Structural Consultant: WSP
Services Consultant: WSP
Project Manager: WSP
Cost Consultant: WSP
Project Title: Great Ormond Street Hospital Phase 2 B

Drawing Title: WEST ELEVATION
2015 update
Drawing Number: 00_2B_E_W
Revision: C11
Scale @ A1: A1_1:200 - A3_1:400
Date:

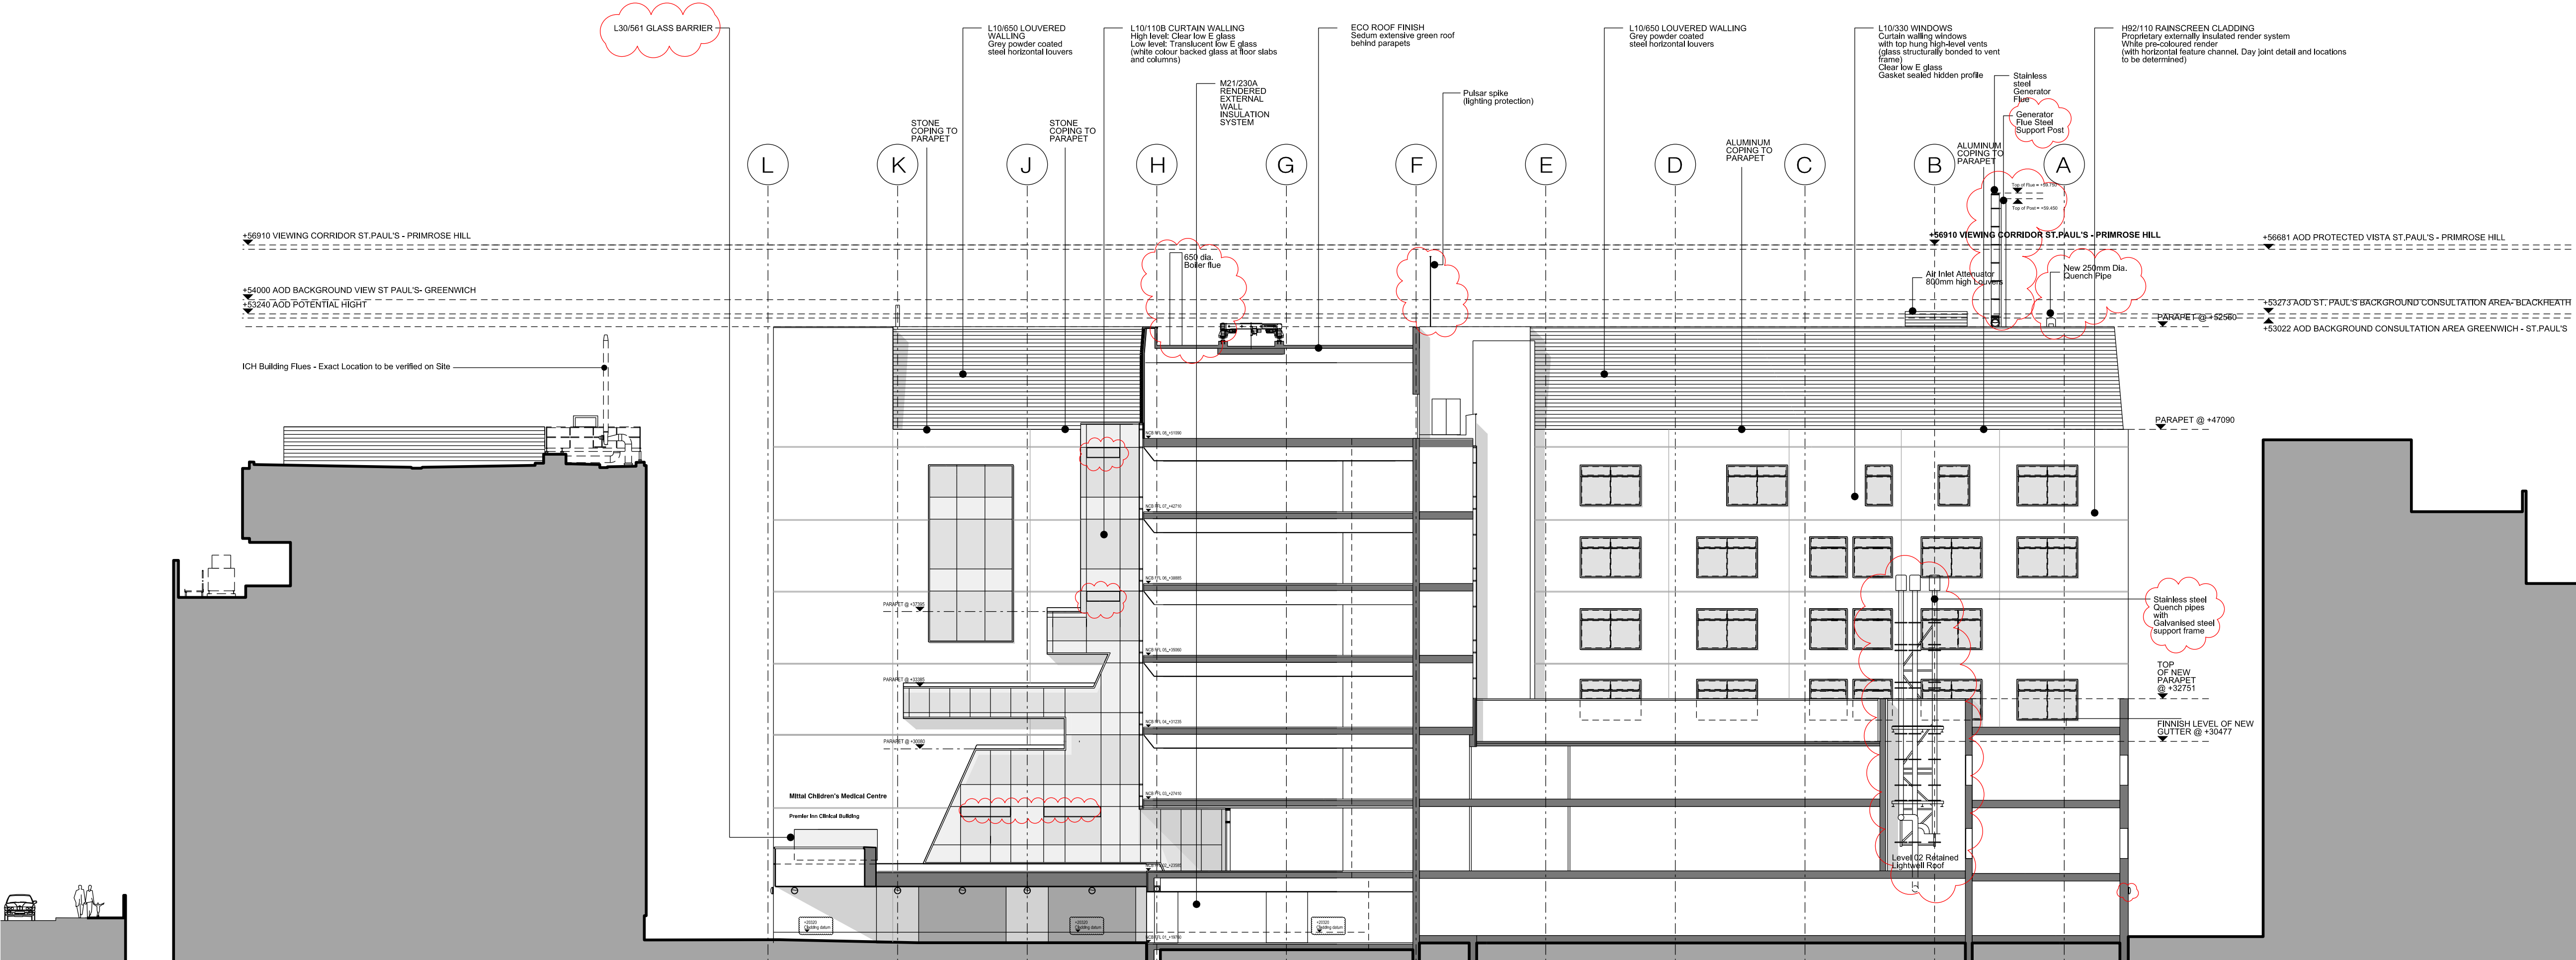
The following changes are listed below
-minor adjustments to mullion position between grids K & H
-notes added

C3 Louvres added; Pre-Application review	20.11.14 JD
C2 Amended Mullion positions in accordance with internal room changes Updated Level 2 Courtyard terrace in accordance to RFI B/40 Updated Quench pipes in accordance with RFI F/45	28.07.14 MN
C1 Added Generator Flue in accordance to RFI F/45 (Subject to planning permission approval) Construction Issue	26.05.14 MN
T4 Updated for Disney imagineers	09.04.14 ZL
T3 Glass Specification Update	23.01.14 AMA
T2 Glass NBS Refs Added	05.09.13 AMA
T1 Updated for Tender Issue Drawing Updated to GOSH Comments	17.01.13 AA
04 Drg no changed and road level raised	19.09.12 MG
03 drawing updated to GOSH comments	07.09.11 AA
02 Elevation updated	26.05.11 AA
01 Windows and Parapet revised	12.05.11 AA
A Windows Revised	29/03/11 GH
